Project	IEEE 802.16 Broadband Wireless Access Working Group < http://ieee802.org/16 >	
Title	Problems with Initial Ranging in OFDM PHY and a Solution	
Date Submitted	2005-03-12	
Source(s)	<p>David A Castelow, Gavin Meakes, Eyal Verbin</p> <p>Airspan Communications, Cambridge House, Oxford Road, Uxbridge, UK</p> <p>Voicemail: +44 1895 467281 Fax: +44 1895 467202 mailto:dcastelow@airspan.com</p> <p>Joël Demarty, Ambroise Popper</p> <p>SEQUANS Communications</p> <p>101-103 bld Mc Donald, 75019 Paris, France</p> <p>Voicemail: +33 1 44 89 48 07 mailto:joel@sequans.com</p> <p>Lei Wang</p> <p>Cygnus Multimedia Communications</p> <p>mailto:lwang@cygnuscom.com</p>	
Re:	Supporting document for Comment to 802.16maint (LB17).	
Abstract	Changes required in to resolve ambiguities and errors in diagrams for Initial Ranging for OFDM and OFDMA PHY modes.	
Purpose	The document is intended for consideration within the comments resolution process.

Problems with Initial Ranging in OFDM PHY and a Solution

*David A Castelow, Gavin Meakes, Eyal Verbin, Airspan
Joël Demarty, Ambroise Popper, SEQUANS Communications
Lei Wang, Cygnus Multimedia Communications
March 2005*

Figure 60 – Initial Ranging – SS (part 1)

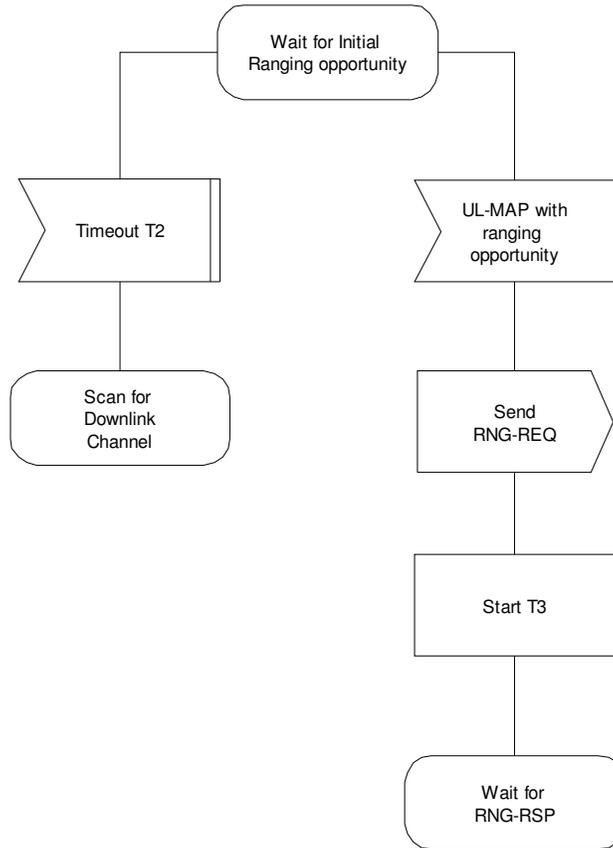
Test "Time to increase power?" does not seem to have a timer associated with it. It is in conflict with the text at [2, page 178, line 53 and page 179, line 6]. In these lines the power is required to be increased at each step. However, the change in power is not defined in the standard, and so the power step could be zero or changed dynamically. We suggest replacing the power step with an instruction to adjust the power.

[Replace Figure 60 with the following figure:]

Figure 61 – Initial Ranging – SS (part 2)

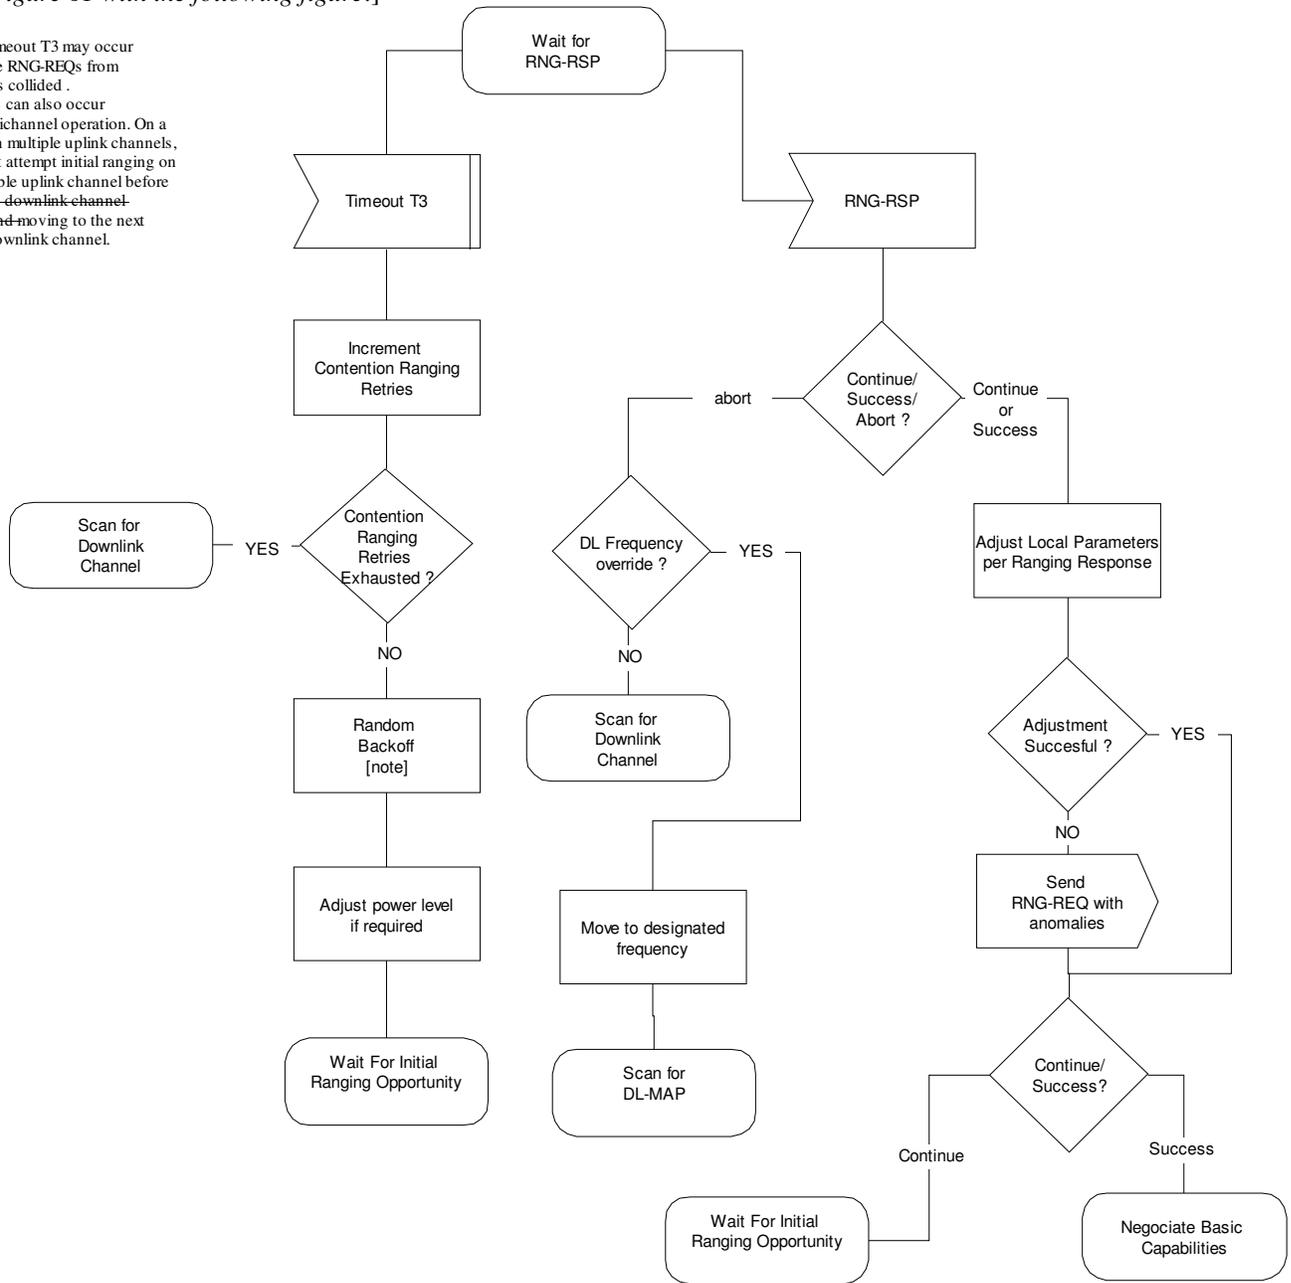
When the SS fails to range properly on a given downlink channel, [1] (Figures 60, 61, 85, 86) instructs the SS to mark the channel as unusable and start a timer T19 during which the channel remains unusable. This timer is SS specific (see section 10.1) and has no lower bound defined. An SS can implement this timer as 0.

We believe this timer T19 belongs to the scanning algorithm which is implementation dependent. As a consequence, this timer should be removed from the specification.

[Replace Figure 61 with the following figure:]

NOTE—Timeout T3 may occur because the RNG-REQs from multiple SSs collided. T3 timeouts can also occur during multichannel operation. On a system with multiple uplink channels, the SS must attempt initial ranging on every suitable uplink channel before ~~marking the downlink channel unusable and moving to the next available downlink channel.~~

Figure 85 – CDMA Initial Ranging – SS (part 1)

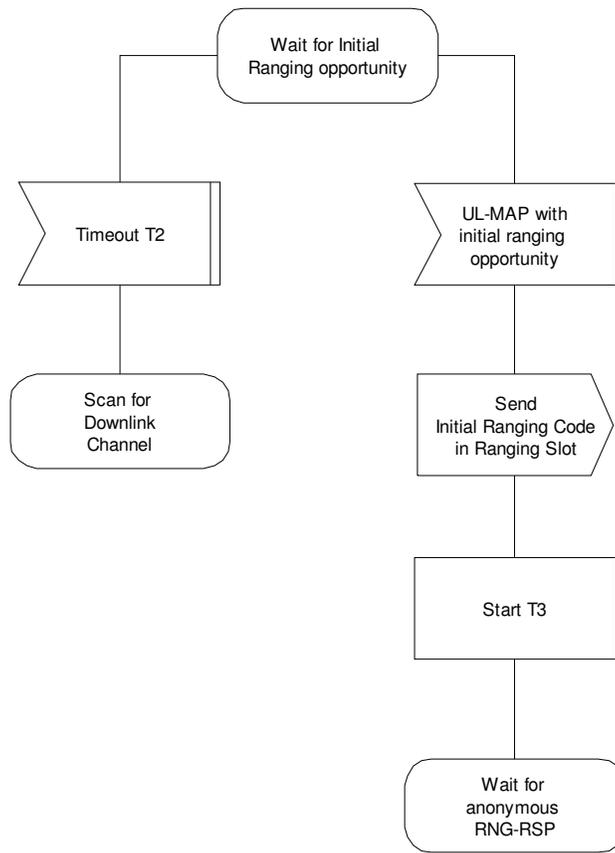
At page 29, line 17, add the following:
[Replace Figure 85 with the following:]

Figure 86 – CDMA Initial Ranging – SS (part 2)

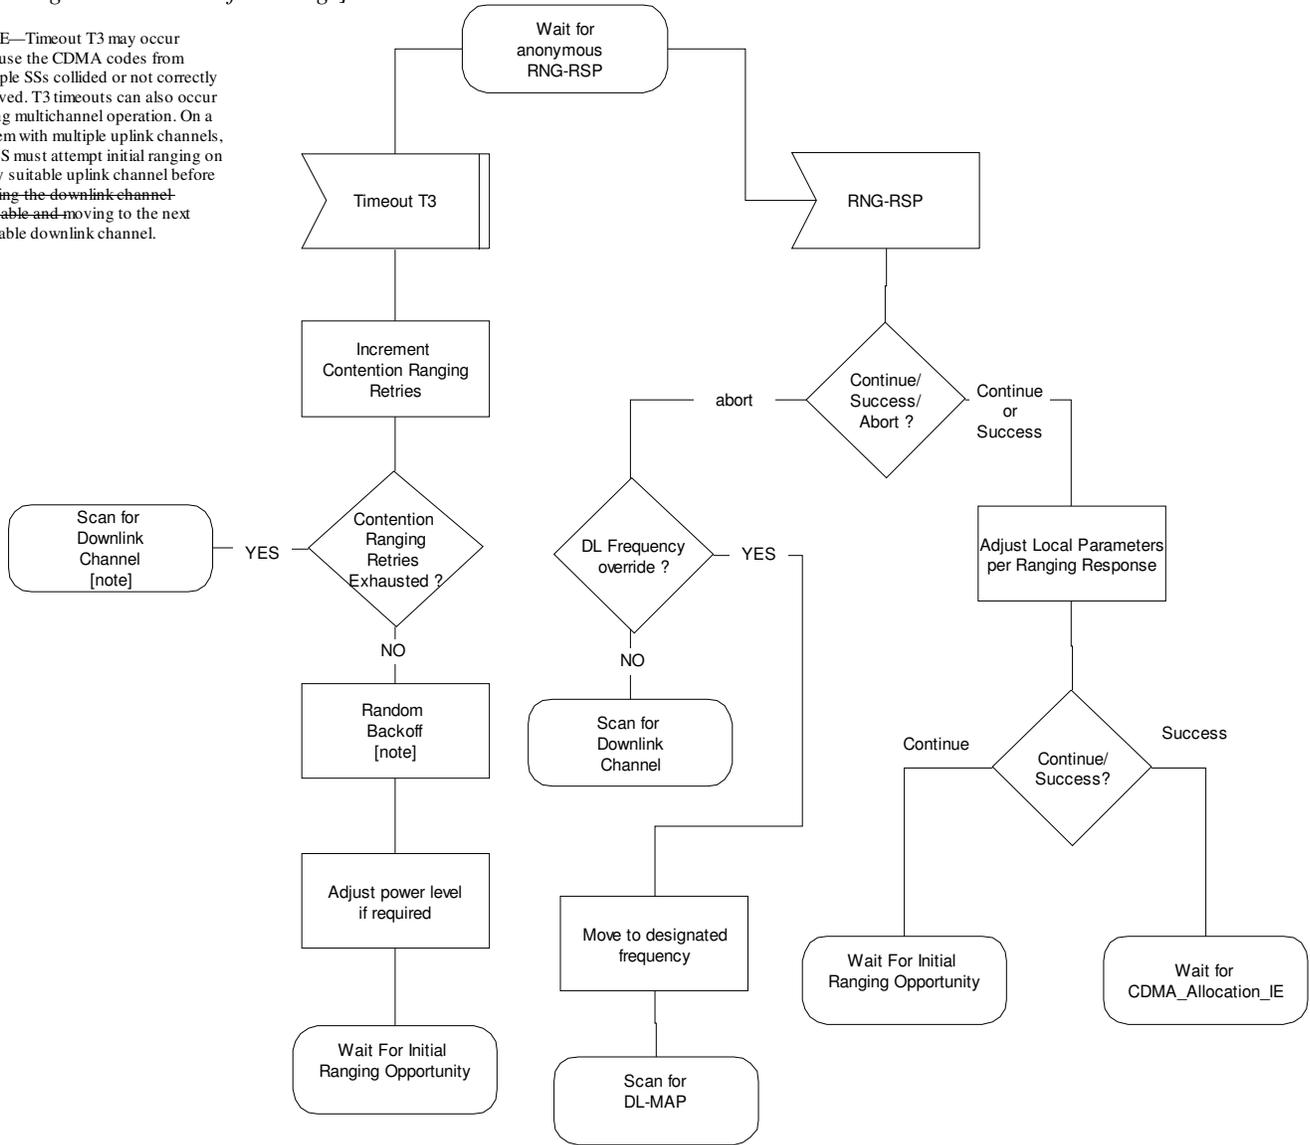
[Replace Figure 85 with the following:]

NOTE—Timeout T3 may occur because the CDMA codes from multiple SSs collided or not correctly received. T3 timeouts can also occur during multichannel operation. On a system with multiple uplink channels, the SS must attempt initial ranging on every suitable uplink channel before marking the downlink channel unusable and moving to the next available downlink channel.

Figure 86a – CDMA Initial Ranging – SS (part 3)

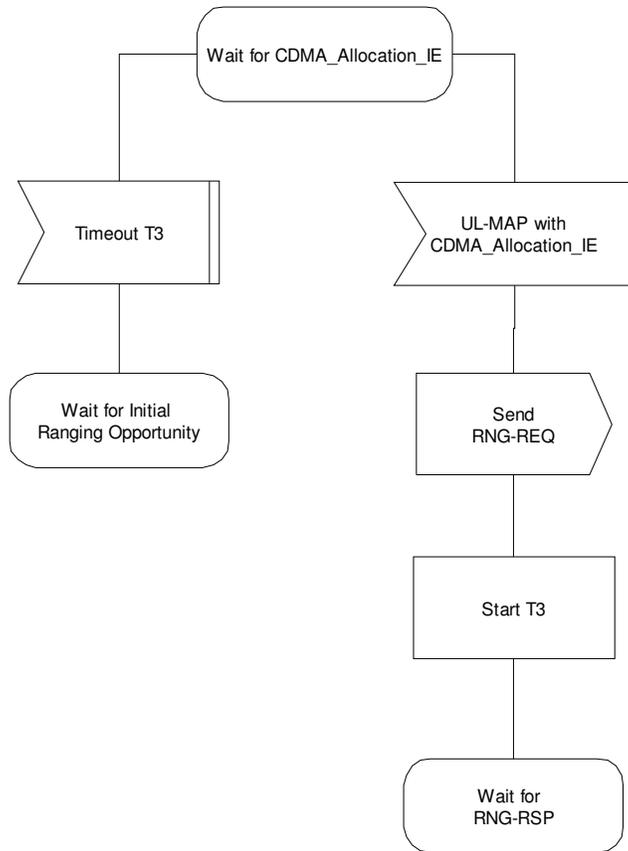
[Insert the following Figure:]

Figure 210a – Subchannelized Initial Ranging – SS (part 1a)

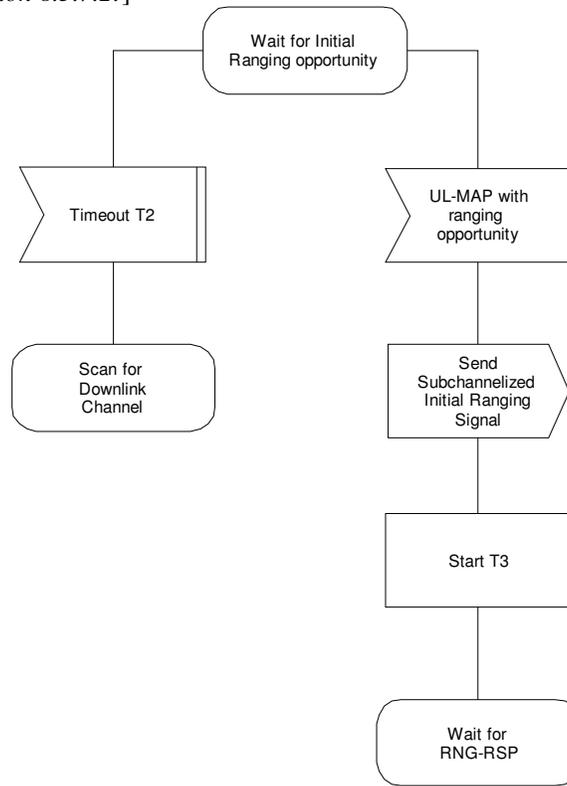
SSs that compute their $P_{TX_IR_max}$ to exceed their maximum power level and SSs which have attempted initial ranging with the maximum power level using RNG-REQ may, if the BS supports subchannelization, attempt initial ranging in an initial ranging slot using the following burst format, to be referred to as the Subchannelized Initial Ranging Signal and as indicated in Figure 210a:

[Include the following diagrams in section 8.3.7.2:]

Figure 210b – Subchannelized Initial Ranging – SS (part 1b)

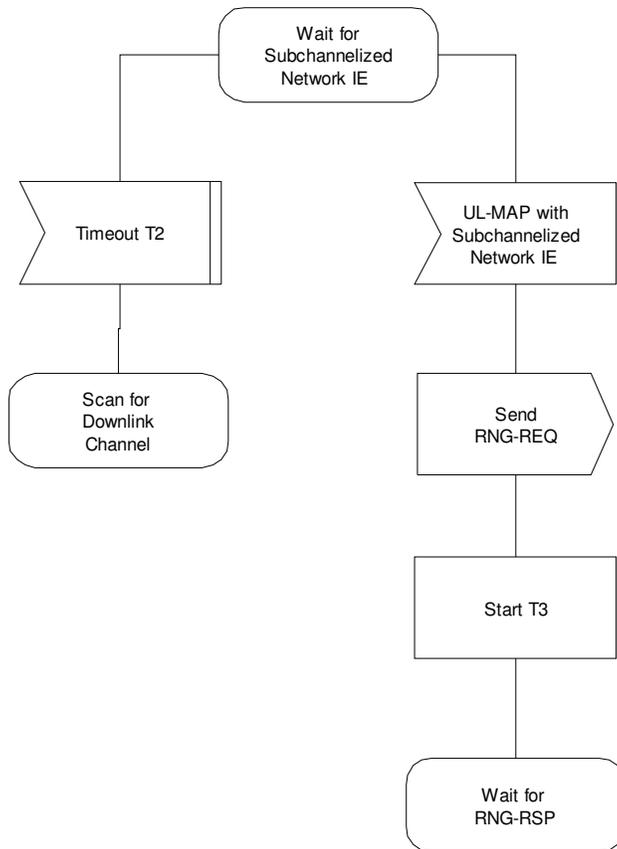
The BS need only detect that energy is sent on a single subchannel and may respond by allocating a single subchannel identifying the SS by the Transmit Opportunity, Frame Number and ranging subchannel in which the transmission was received. The allocation is accomplished by sending an UL-MAP IE containing a Subchannelized_Network_Entry_IE (see 8.3.6.3.3) and transmitted using the Initial Ranging CID, as shown in Figure 210b. The allocated bandwidth shall be big enough as to contain at least one RNG-REQ message.
